SEWAGE DISPOSAL SYSTEM

A REPAIR

MARYLAND STATE DEPARTMENT OF HEALTH

SUBDIVISION _____ ROAD 6287 Lawyers Hill Road LOT _____

INDICATE NORTH. - NAME ADJOINING ROADWAY AS BASE LINE.

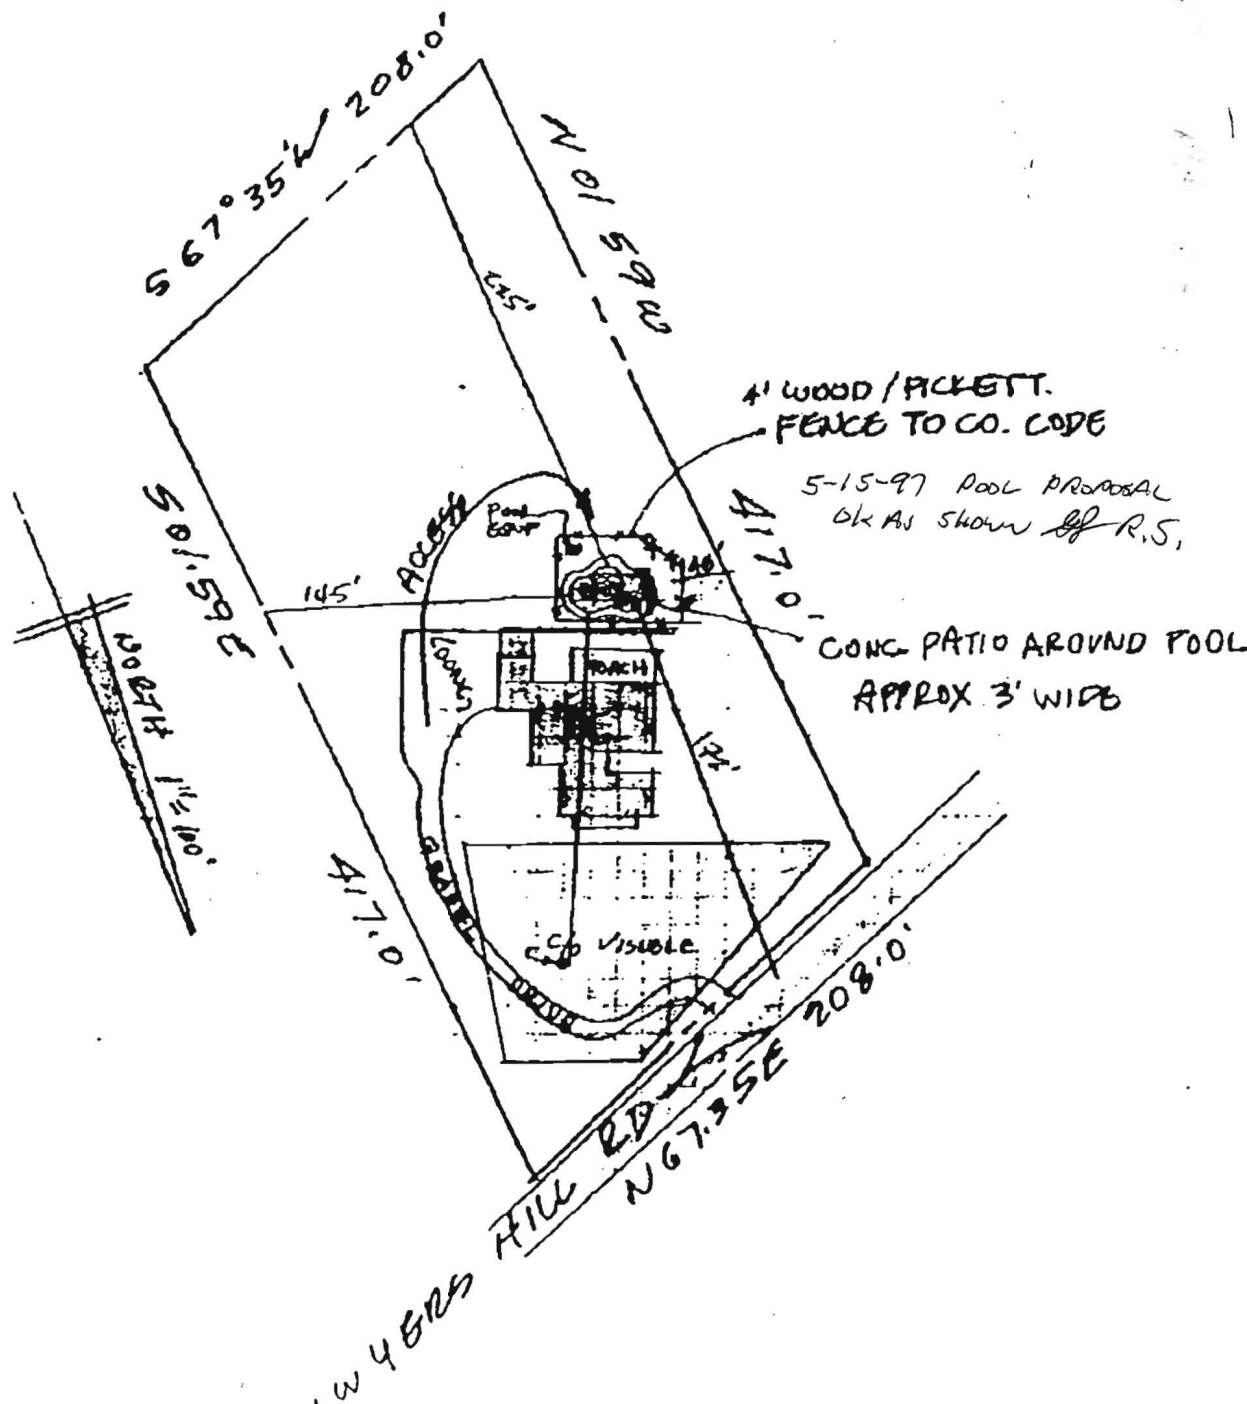
SEPTIC TANK, LEVEL OK Top CLEANOUTS NO

DISTRIBUTION BOX, LEVEL 6" below grade

REMARKS 5/31/77 - Tank OK but not hooked up
Dug Ditch & Call for inspection
1 1/2" broken (cut) water supply, must be re-connected w/
cast iron pipe around it; complete trench R.M.

DATE SYSTEM APPROVED 2 June 77 INSPECTOR R. Riggs
